FDI	ENGINEERING CHANGE ORDER		ECO NO: 15-010
			Page 1 of 1
TITLE	DWG NO.	CURRENT REV	NEW REV
uEZGUI-1788-43WQR	uEZGUI-1788-43WQR-BA	7.2	7.3
uEZGUI-1788-43WQR-NT	uEZGUI-1788-43WQR-BA-NT	7.2	7.3

SHARP LCD (DG28)

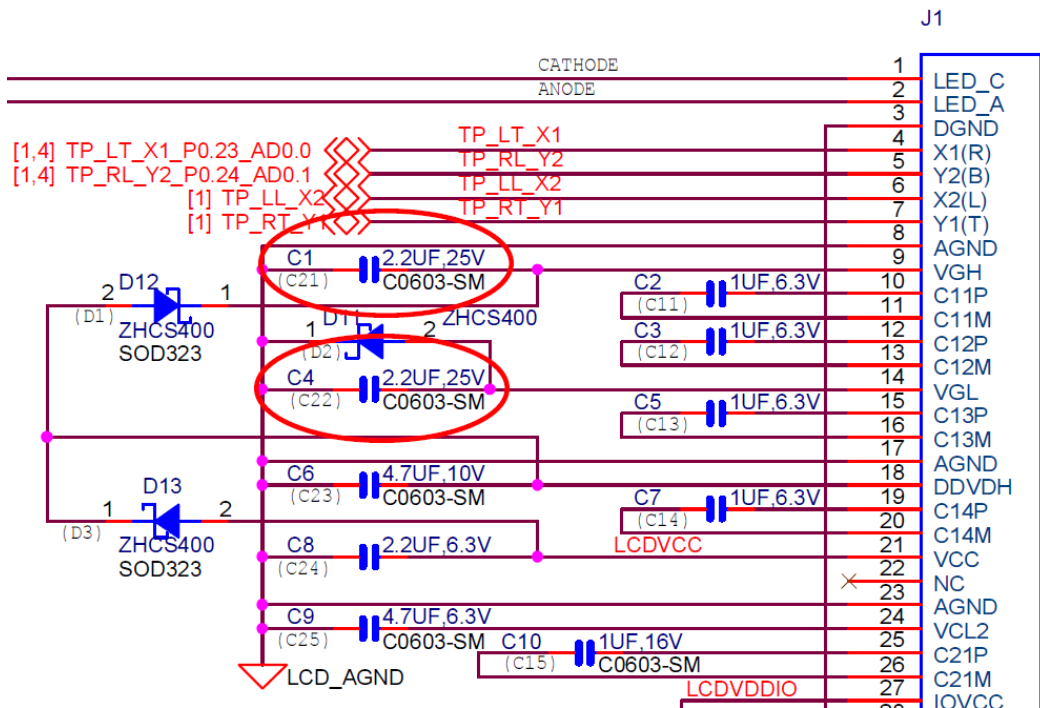
- Change two capacitors to increase the voltage rating. This will provide better voltage tolerance and increase the reliability of the LCD circuit. No modifications to PCB artwork or rework of existing units is needed.

1. Change C1 & C4 from 2.2uF, 10V (FDI PN C500274) to 2.2uF, 25V (FDI PN C500394). No change in PCB footprint and the capacitor tolerance improves from 20% to 10%.
